1. Historic District Commission Virtual Meeting

Historic District Commission Meeting

7:00pm - April 13, 2021

HDC Work Permit Staff Review

1 SITE PLAN
PV-2 SCALE: 1" = 10'

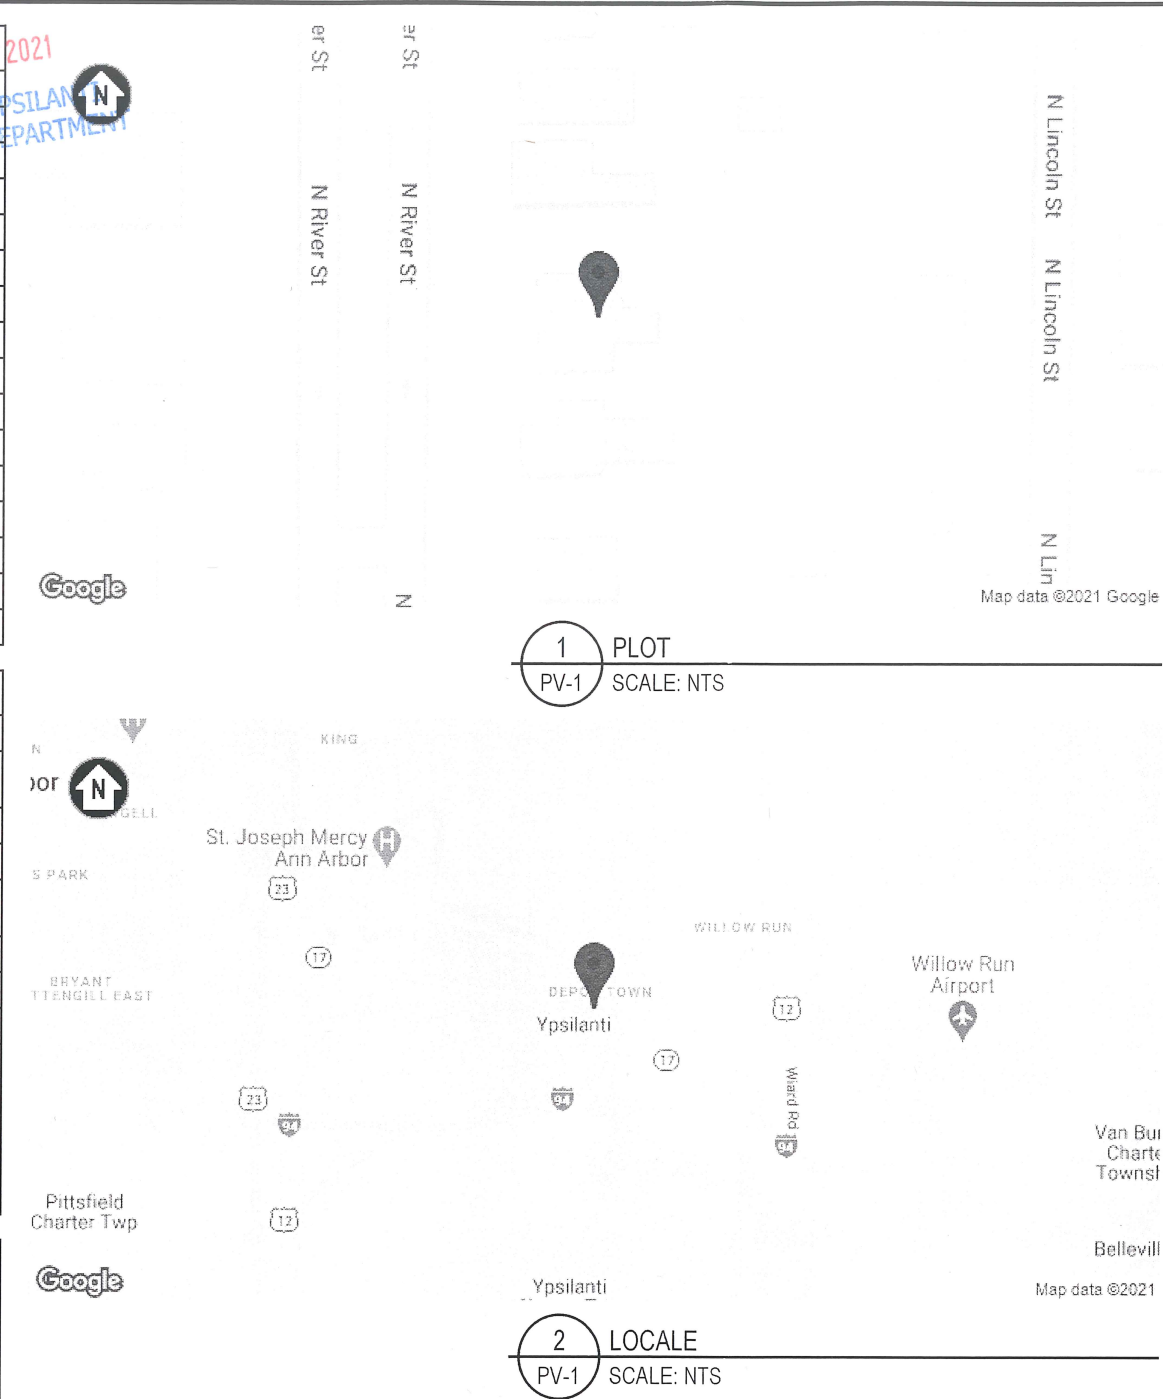
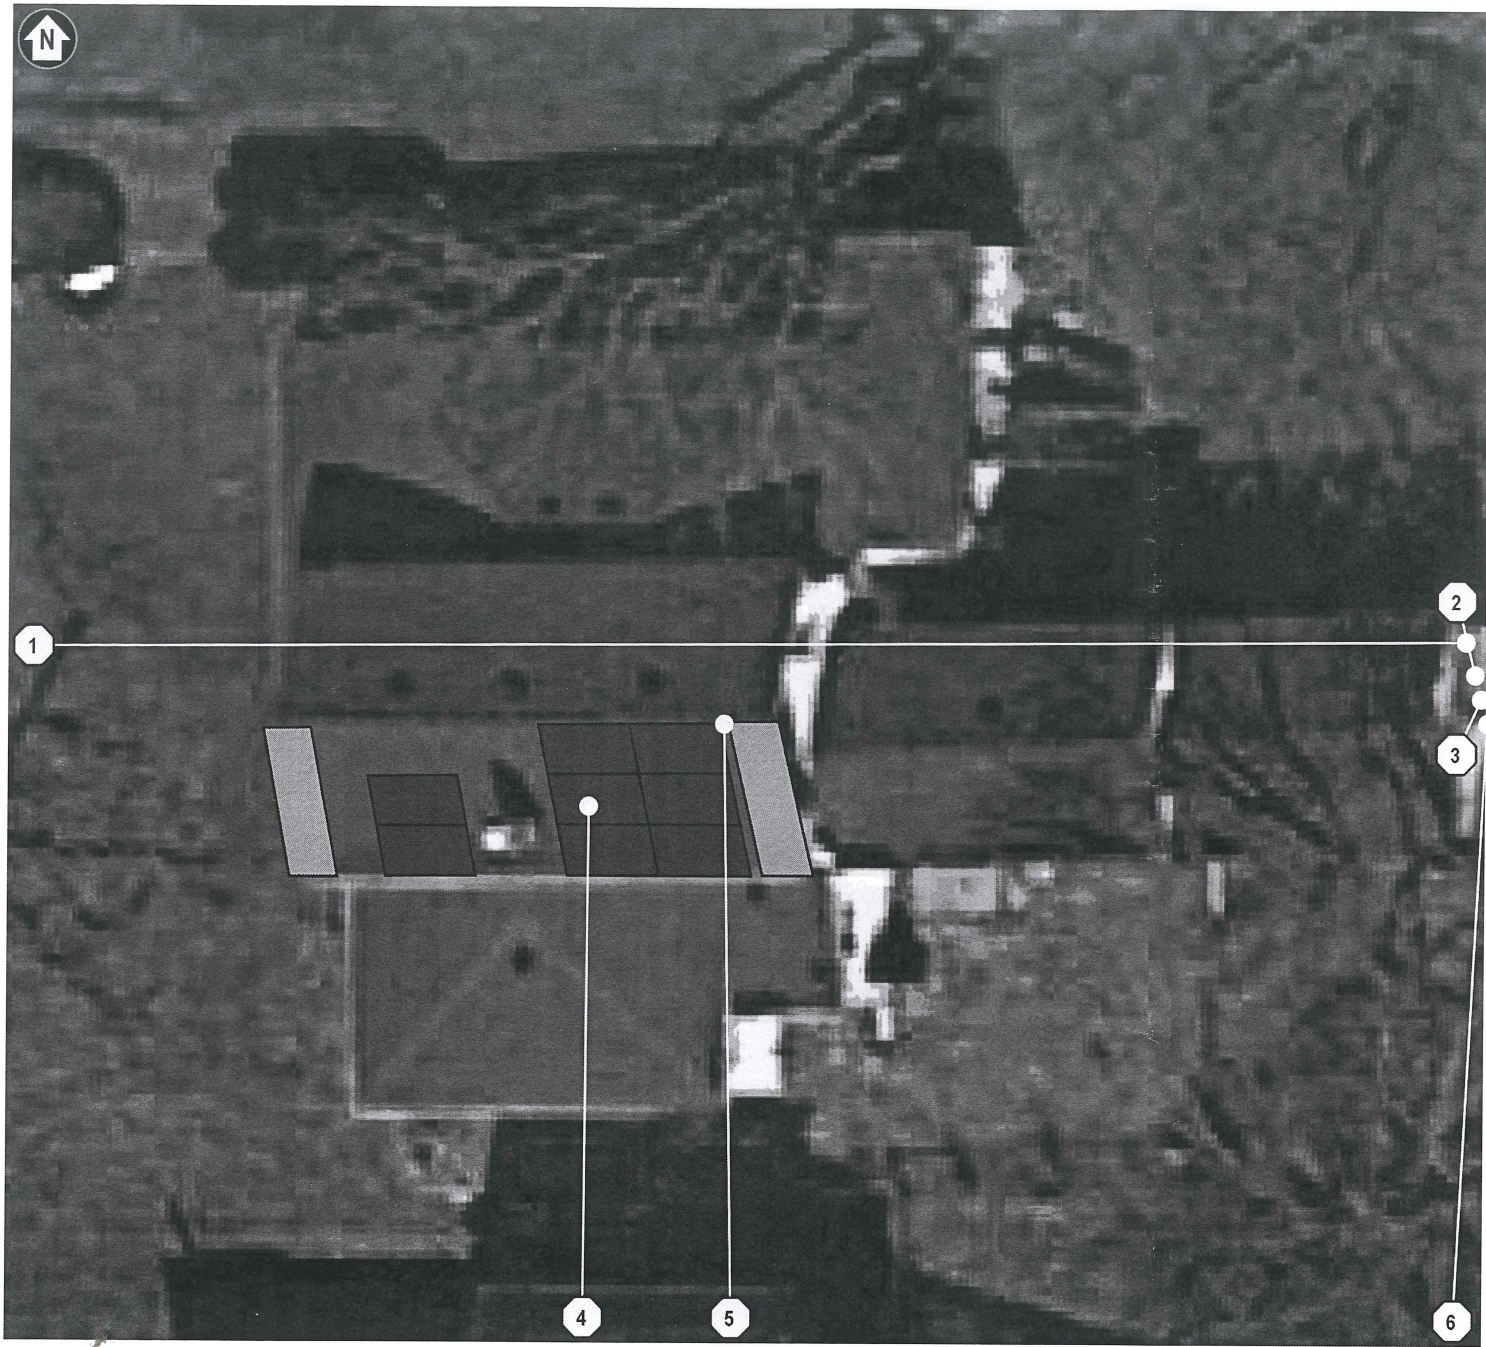
1. Two solar array installations are proposed for the south slope of the central gable roof, each consisting of LG NeON black solar panels.
 - a. One array is located west of the chimney and has two panels.
 - b. The other is east of the chimney and has six panels.
2. The panels will be installed at an angle parallel with the slope of the roof.
3. The rails/anchors will utilize an Ironridge Flush Mount System; mounted to the roof trusses with a fastener.
4. The utility meter, service panel, disconnect, and inverter, will all be located on the east elevation of the rear ell; out of view from the right-of-way.

6. Overall, the installation meets most of the guidelines outlined in the HDC Alternative Energy Fact Sheet, except the consideration for visibility.
 - a. HDC should consider that the installation will be visible from the right-of-way, although not on the façade.
 - b. There are other examples of visible solar installations in the district.
 - c. This installation, although on the side of the building, is on the core mass of the structure, rather than a secondary mass, such as the rear ell.
 - d. Staff has provided both an approval and denial motion depending on the HDC's interpretation of the Standards. Please refer to the HDC Alternative Energy Fact Sheet for guidelines specific to solar panels.

Move to issue a Certificate of Appropriateness for the work at 222 N River as submitted in the application dated March 18, 2021, installation of two solar arrays on the south roof slope, using LG NeON solar panels in black, and Ironridge anchor system as specified. The inverter, disconnect, and other power apparatuses shall be located on the rear east elevation. Approval is granted with the understanding that the work is removable and although visible, the panels are not street-facing and have a minimal impact on the historic setting.
